TO: All U.S. Ford and Lincoln Dealers
SUBJECT: NEW VEHICLE DELIVERY HOLD - Compliance Recall 24C33
Certain 2024 Model Year Maverick Vehicles – 2nd Row Seat Top Tether Anchor Bolt Repair
REF: NEW VEHICLE DELIVERY HOLD - Advance Notice - Compliance Recall 24C33
Dated October 21, 2024

CERTAIN 2024 MODEL YEAR MAVERICK VEHICLES – 2ND ROW SEAT TOP TETHER ANCHOR BOLT REPAIR

FIGURE 1

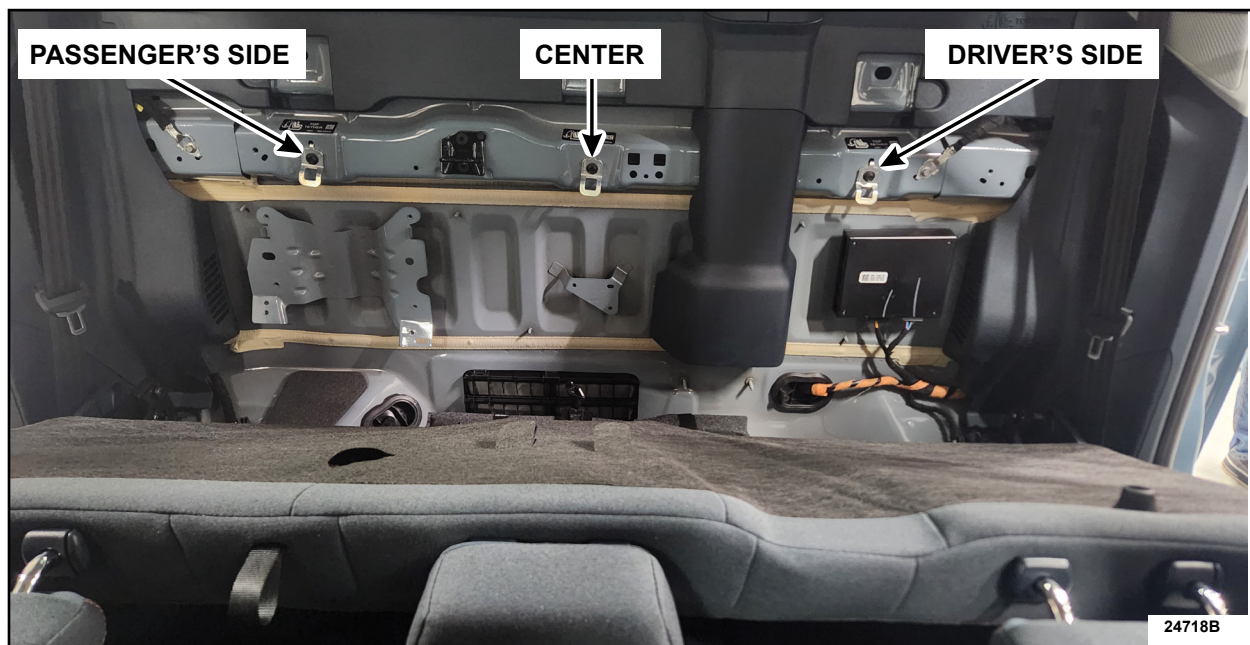
1. Review the VIN list below and Figure 1 to determine the top tether point location(s) that will need to be repaired.

VIN	Passenger's Side	Center	Driver's Side
3FTTW8M36RRB44244			X
3FTTW8B92RRB40618			X
3FTTW8J90RRB63039			X
3FTTW8J90RRB39842			X
3FTTW8M3XRRB44361			X
3FTTW8M39RRB47140	X	X

FIGURE 4

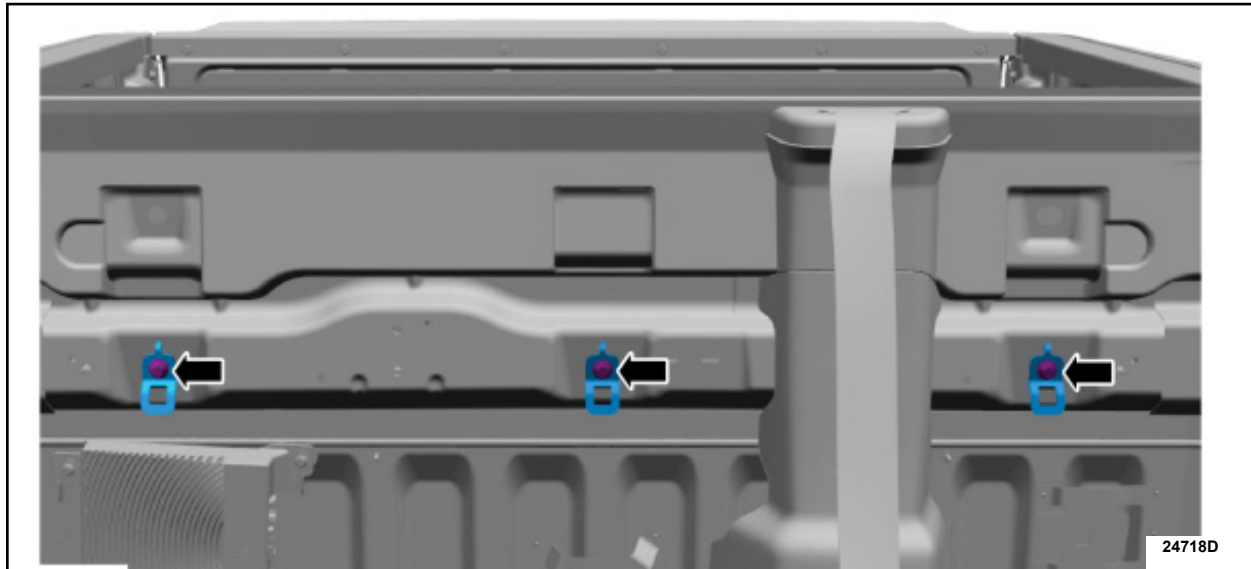
4. Remove the bolt(s) and the top tether anchor(s) from the location(s) that need repair. See Figure 4.

FIGURE 5

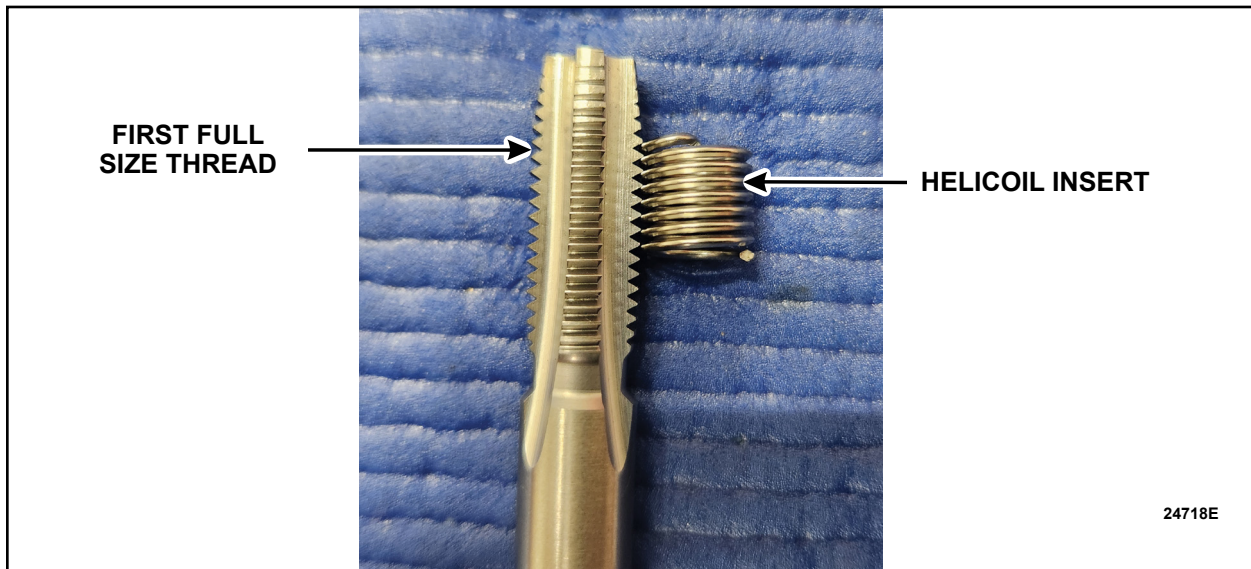
5. Place the tap and Helicoil insert on a flat surface and align the top edge of the helicoil with the first full size thread on the tap. See Figure 5.
